BOARD OF WATER SUPPLY

Subject: Honolulu Board of Water Supply (BWS) Comments on the Red Hill
Administrative Order on Consent (AOC) Statement of Work (SOW)
Sections 6 and 7 Groundwater Modeling Working Group Meeting No. 9
held March 16, 2018

Figure 1. Observed October 2017 and Predicted Steady State Groundwater Levels

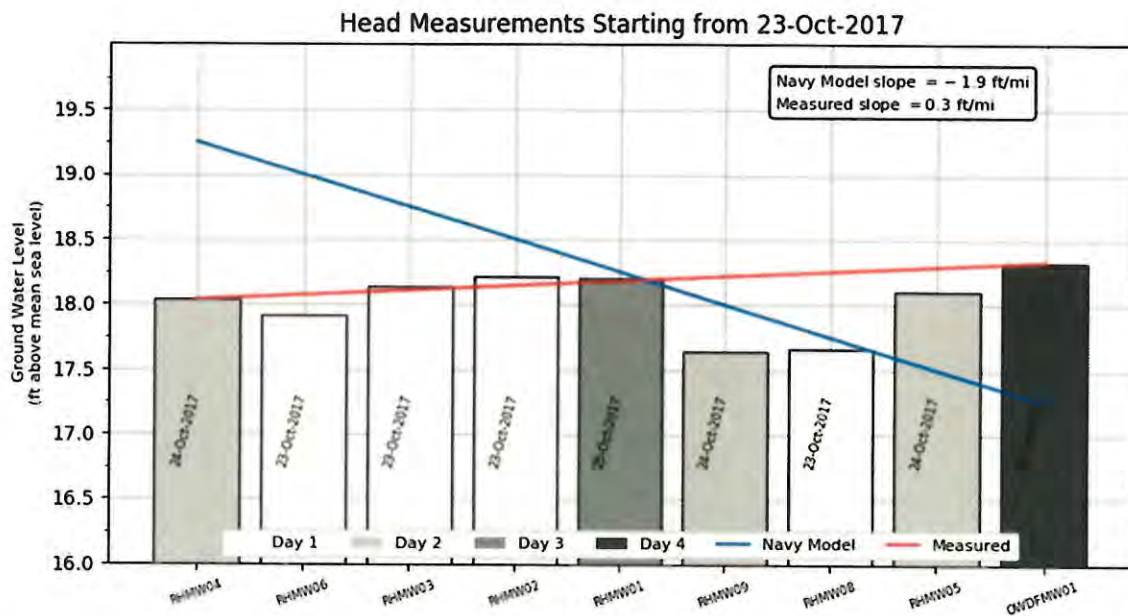
Comparison of the Navy's predicted 2017 steady state groundwater levels with levels observed at different 2017 dates shows the same alarming disparity for all of the time periods examined. We estimated groundwater levels using depth to groundwater data presented in Appendix A Table A.4-1 of DON (2018a) and corrected elevations for tops of well casings presented in Table 2 of DON (2018b) to create the plots below. Whether for October, July, April, March, February, or January 2017 (Figures 1 to 6 below), the observed levels at monitoring wells RHMW04 and OWDFMW01 consistently show

negligible or very small differences even though there may have been one to four days between measurements. The BWS also examined the data for November 18, 2016 when all wells were measured on the same day and found similar results.

The BWS has little to no confidence in the interim groundwater flow model. The Navy's predicted 2017 steady state groundwater levels do not match any observed levels made during six different months in 2017 at the monitoring wells on the Red Hill Facility. Nor do the model's predictions match the Navy's 2017 steady state observed levels for these same wells. Furthermore, the Navy's measurements of groundwater levels at Red Hill Shaft are 0.8 to 0.9 feet (ft.) higher than the observed level at monitoring well RHMW02, where the greatest contamination has been measured, for five of the six different 2017 time-periods. This contradicts the Navy's modeling results that pumping at Red Hill Shaft will maintain a large capture zone across the entire facility. The BWS asks how can the Regulatory Agencies or the SMEs depend on the Navy's interim model to defensibly inform the TUA selection process when the information available throughout 2017 contradicts both the model's predicted 2017 groundwater levels and its predicted large capture zone across the Red Hill Facility from pumping at Red Hill Shaft?
